Planning Commission MEETING AGENDA

Docket/Case/Application Number: New Business

Easton Staff Development Review Comment Responses

PORT STREET COMMONS

INFRASTRUCTURE IMPROVEMENT PLANS

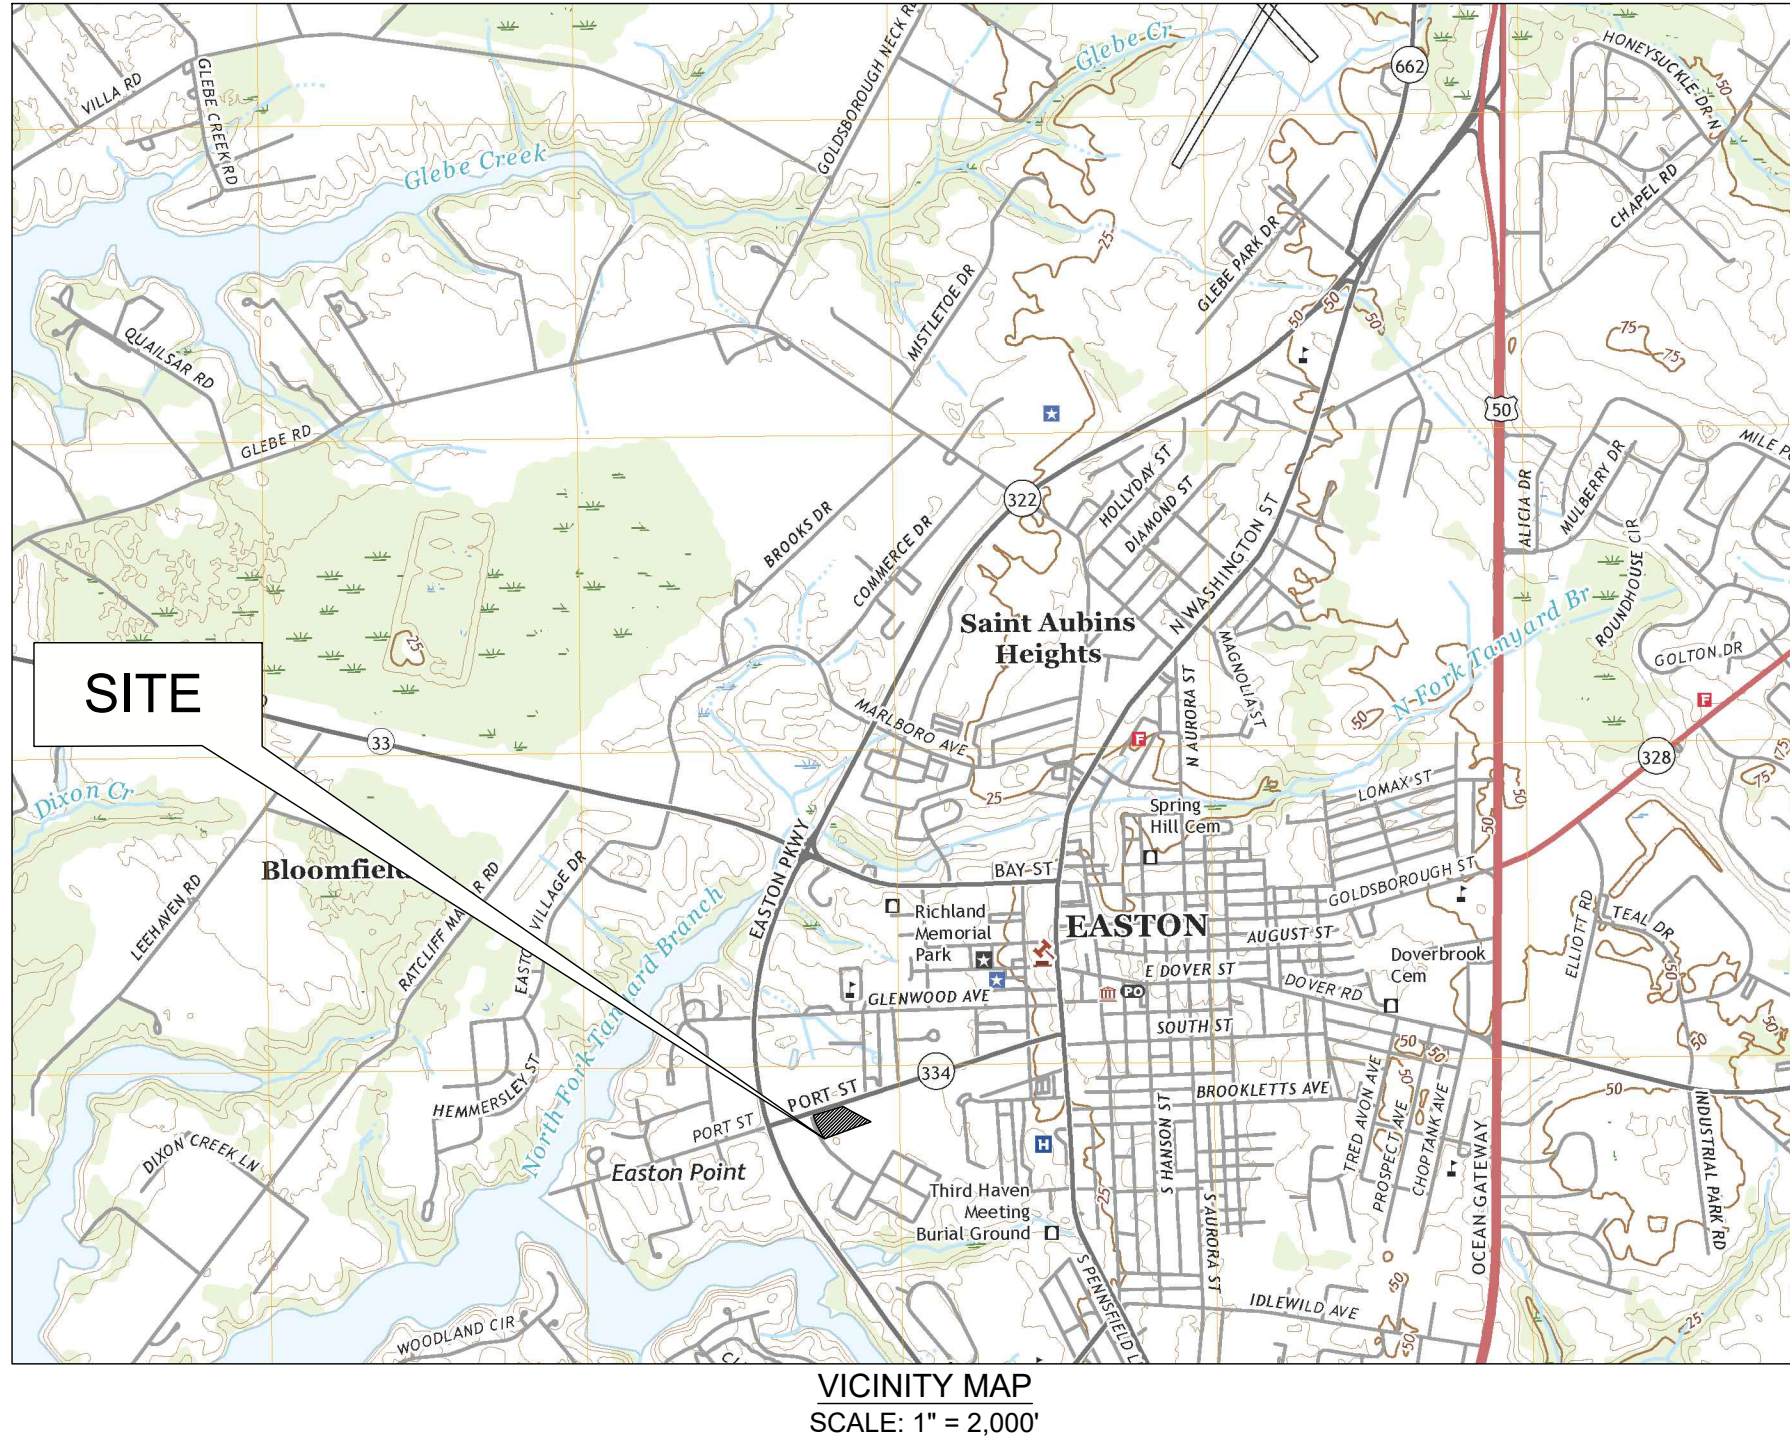
2. Provide a Quality Management summary table indicating ESD Volume Required and Provided (for each Study Point) on the plans (possibly Sheet G-100) and in the Stormwater Management Report.

- N/A
- Add the total maximum building height to the Site Data on sheet G-100.
 - Maximum height has been added to sheet G-100.
- Address the total volume of water being used for the training facility and confirm this is incorporated in the calculations in the Stormwater Management Report.

- **Table has been added to sheet G-100.**

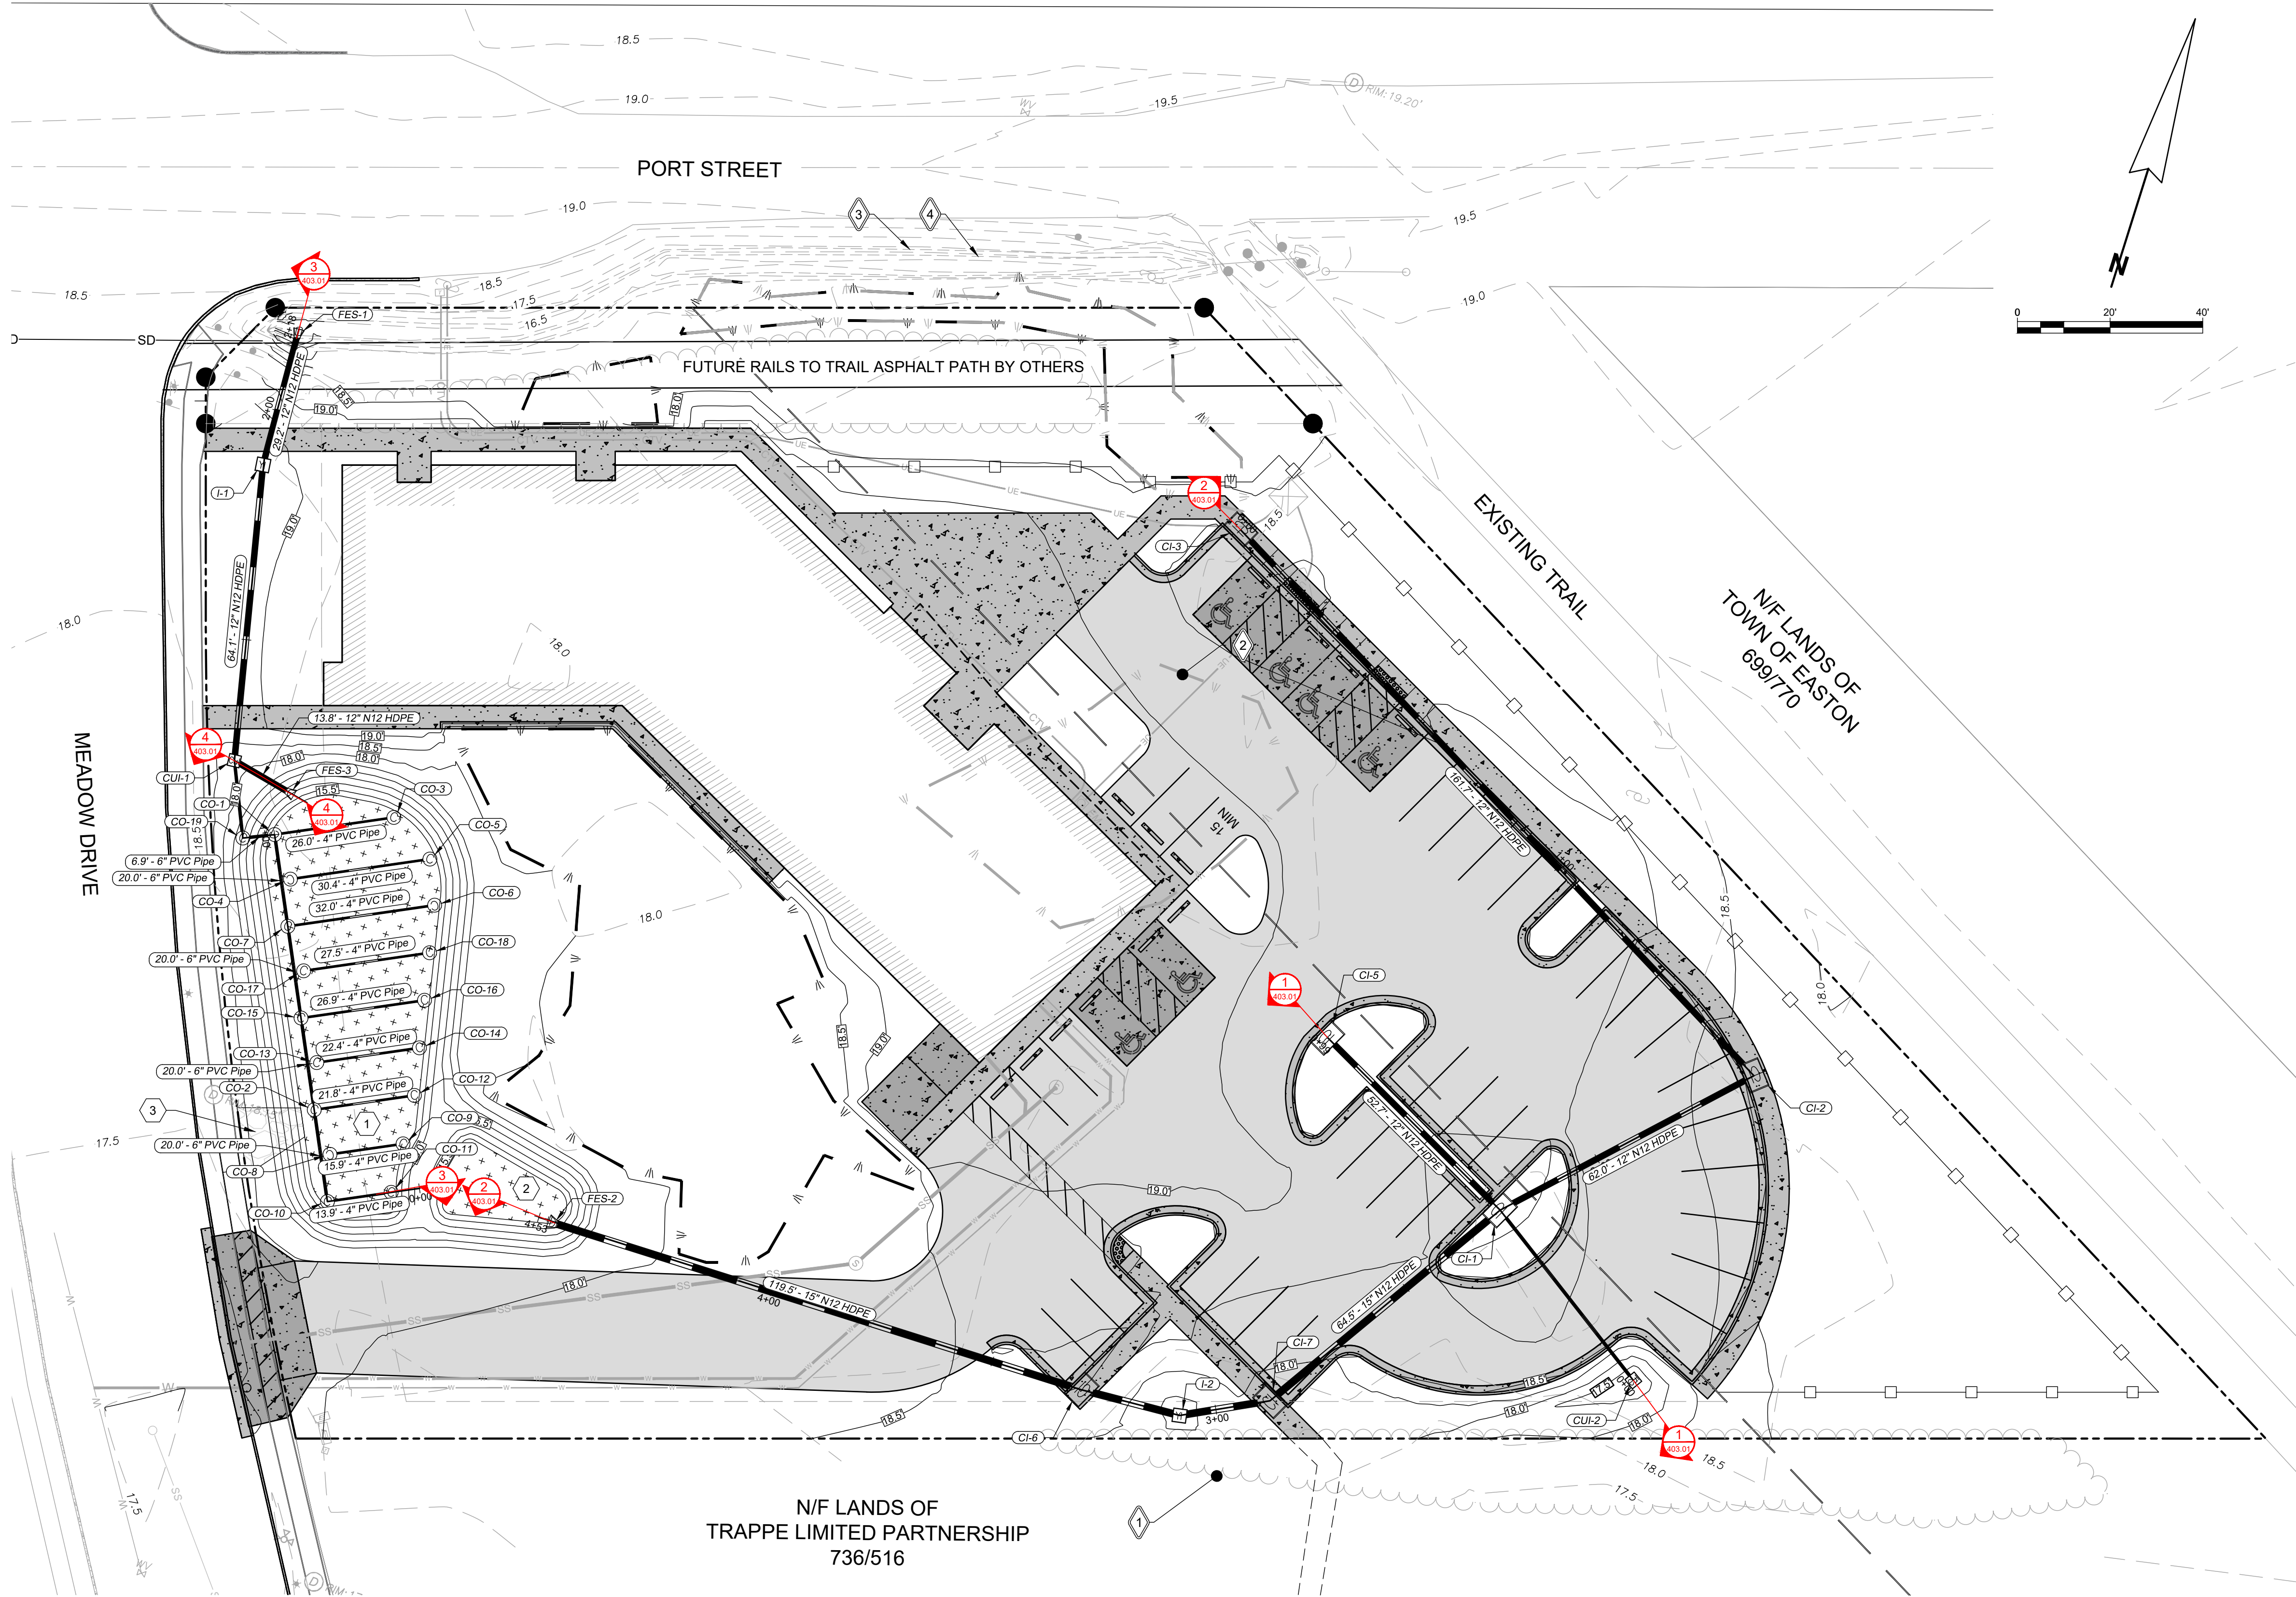
1. **SHEET C-101** - Consider using a concrete entrance at Meadow Gate Drive (TOE-R-4.02). This helps with grade control for the ADA

- **Entrance has been updated accordingly. Detail has been added to sheet C-305.01.**
